## EXHIBIT 1 - STAFF REPORT

**DATE:** March 20, 2024  
**TO:** Landscape Review Committee Members  
**FROM:** Taylor Graybehl, Senior Planner  
**SUBJECT:** Tree Removal Application (L 8-24)

**DOCKET:** L 8-24 (Street Tree Removal)

**REQUEST:** Approval of a tree removal application for the removal of two (2) Trees.

**Figure 2. Application Photos Tree #1.**

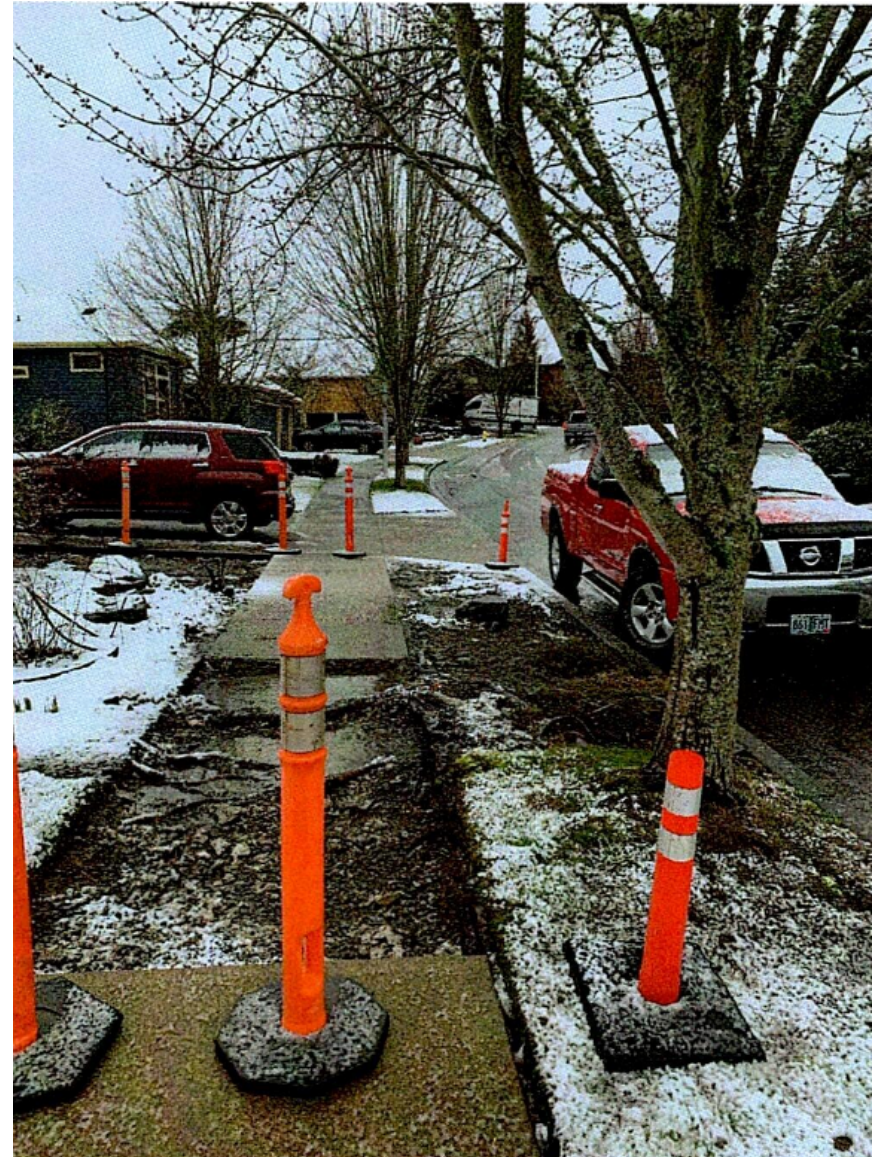
Tree #1 (northern tree). This tree was identified as the tree to be removed as part of the original application, but the tree species was not identified as part of the application. The applicant's imagery shows sidewalk panels removed with roots exposed (see **Figure 2**). It appears the roots have grown to the surface beneath the sidewalk and are now creating a trip hazard that needs to be addressed.

Both tree roots are causing trip hazards that need to be addressed and Engineering would be supportive of the tree(s) removal and replacement.

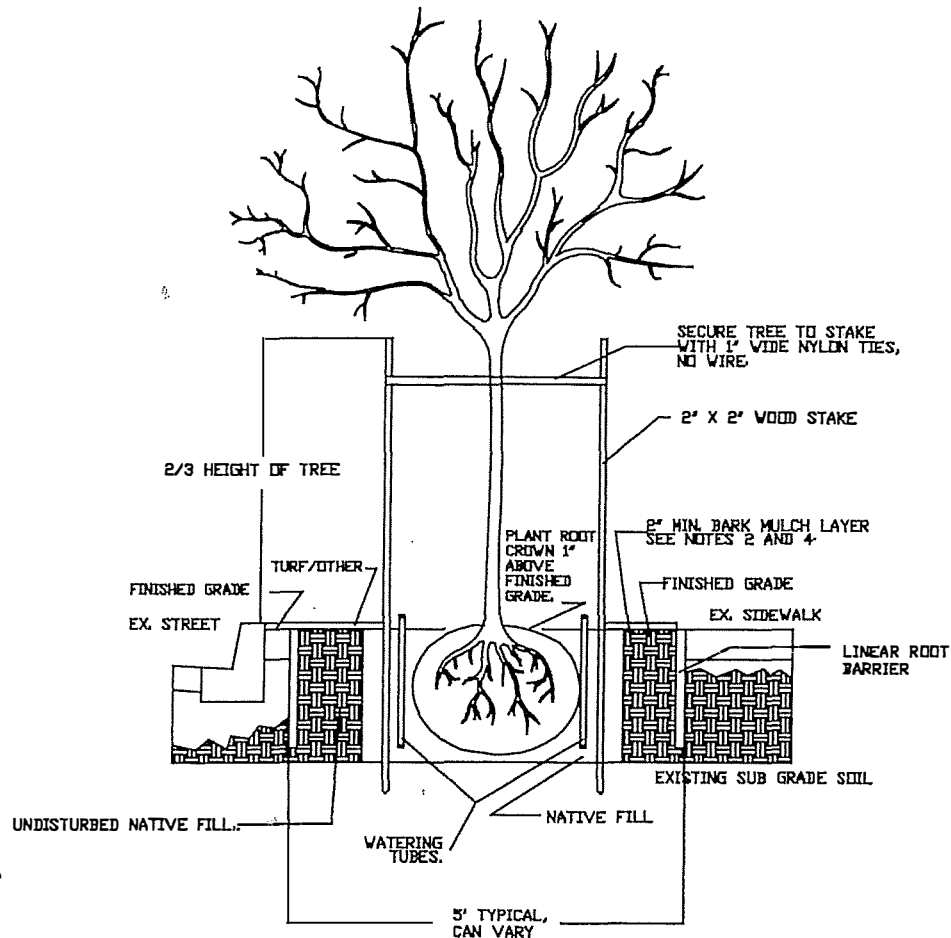
Tree #2 (southern tree). This tree was identified for removal as part of the supplemental application, but the tree species was not identified as part of the application. The applicant has indicated that the tree has impacted their irrigation system and raised the sidewalk (see **Figure 3**). After conducting a site visit, it was found that a trip hazard, which appears to be from the tree's roots, existed within the sidewalk.
